Work Order ID 136445

Item Name: Heli-Access-Step™ LH - High Gear, Short Step, Aerazur Float Compatible

DART SERVICE INSTRUCTION

TO AMEND INSTALLATION INSTRUCTIONS D350-591 REV. G OR EARLIER
AND
INSTRUCTIONS OF CONTINUED AIRWORTHINESS ICA-D350-591 REV. 2 OR EARLIER
REF CANADIAN STC: SH92-6
REF FAA STC: SH967NE

FIGURE 1: CLAMP DETAIL
OPTIONAL CLAMP CONFIGURATION

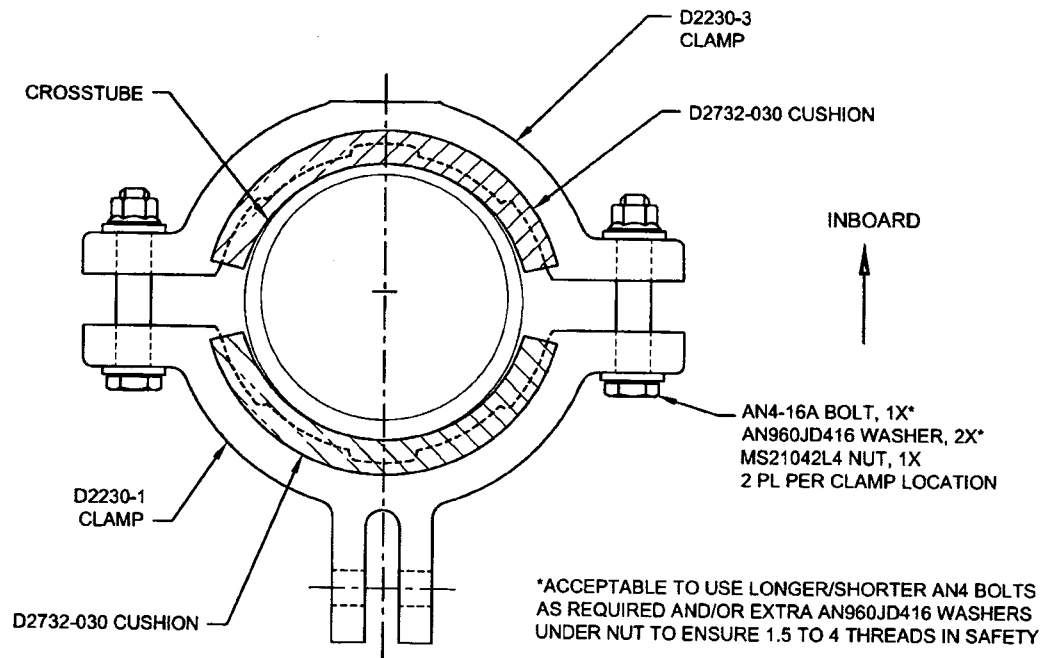
For D350-591-213/-214/-215/-216 steps, customers have the option of installing D2732-030 cushion under the clamps to accommodate varying crosstube diameters and to improve fit, as indicated in Installation Instructions D350-591. This Service Instruction adds longer AN4-16A bolts to the parts list to allow installation of these cushions. See Figure 1 on sheet 2 of this service instruction for reference. Installation of the D2856-400-720 Abrasion Strips per Installation Instructions D350-591 is not required when the cushions are installed.

For D350-591-213/-214/-215/-216 steps at CHG 003, the parts list of D350-591 Rev. G and ICA-D350-591 Rev. 2 is amended as follows:

Qty -213	Qty -214	Qty -215	Qty -216	Part Number	Description
X				D350-591-213	<i>Heli-Access-Step</i> ™, Short Step – High Skid, LH
	X			D350-591-214	<i>Heli-Access-Step</i> ™, Short Step – High Skid, RH
		X		D350-591-215	<i>Heli-Access-Step</i> ™, Short Step – Low Skid, LH
			X	D350-591-216	<i>Heli-Access-Step</i> ™, Short Step – Low Skid, RH
4	4	4	4	AN4-16A	BOLT

VIEW G-G: FWD CROSSTUBE
LH INSTALLATION SHOWN (RH OPPOSITE)
SCALE 6X

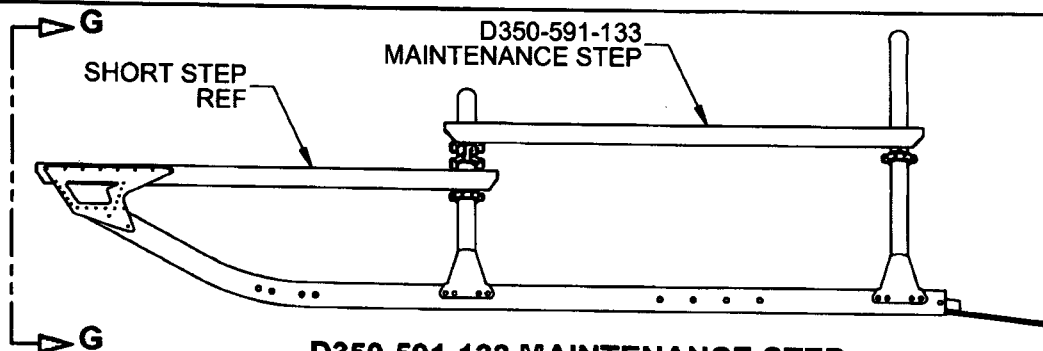
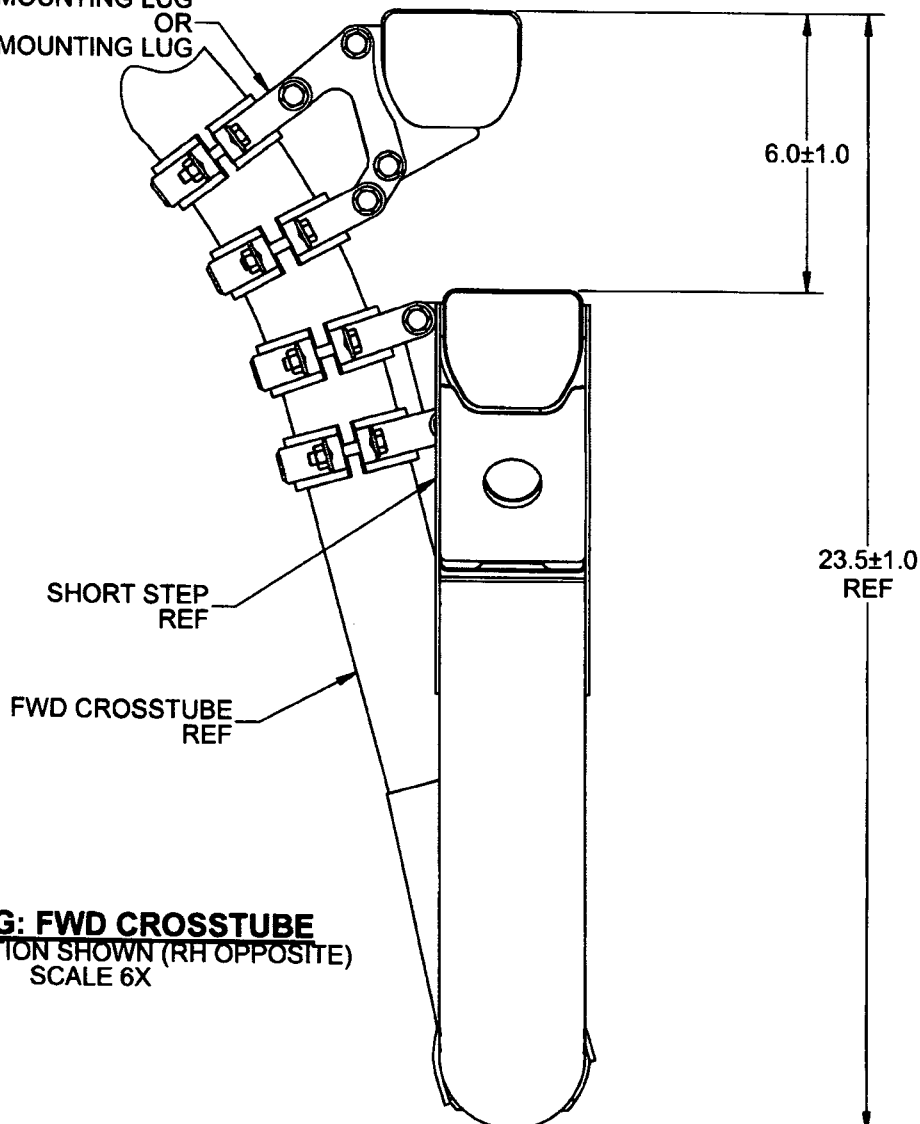
It has come to DART's attention that it may be difficult to fasten the D350-591-133 Aft Maintenance Step and D350-591-213/-214 Heli-Access-Step Installations to the forward crosstube due to variations between crosstubes. For this reason, DART is adding the D3338-1 Mounting Lug to the D350-591-133 Aft Maintenance Step and D350-591-213/-214 Heli-Access-Step Kits at CHG 004 and later.

- 2.1 It is acceptable to install the D3338-1 Mounting Lug in lieu of the D2230-1 Mounting Lug as required to reduce the gap between step and the forward crosstube in accordance with the figures of this service instruction.
- 2.2 The height to set up the D350-591-133 Maintenance Step has been revised from 7.0in to 6.0in $\pm$ 1.0in to provide more flexibility. See sheet 2 of this service instruction.
- 2.3 In all other respects, install the D350-591-133 Aft Maintenance Step and D350-591-213/-214 Heli-Access-Steps in accordance with Section 3.1 of Installation Instructions D350-591 or Section 32.1 of Instructions for Continued Airworthiness ICA-D350-591.

D2230-1 MOUNTING LUG
OR
D3338-1 MOUNTING LUG
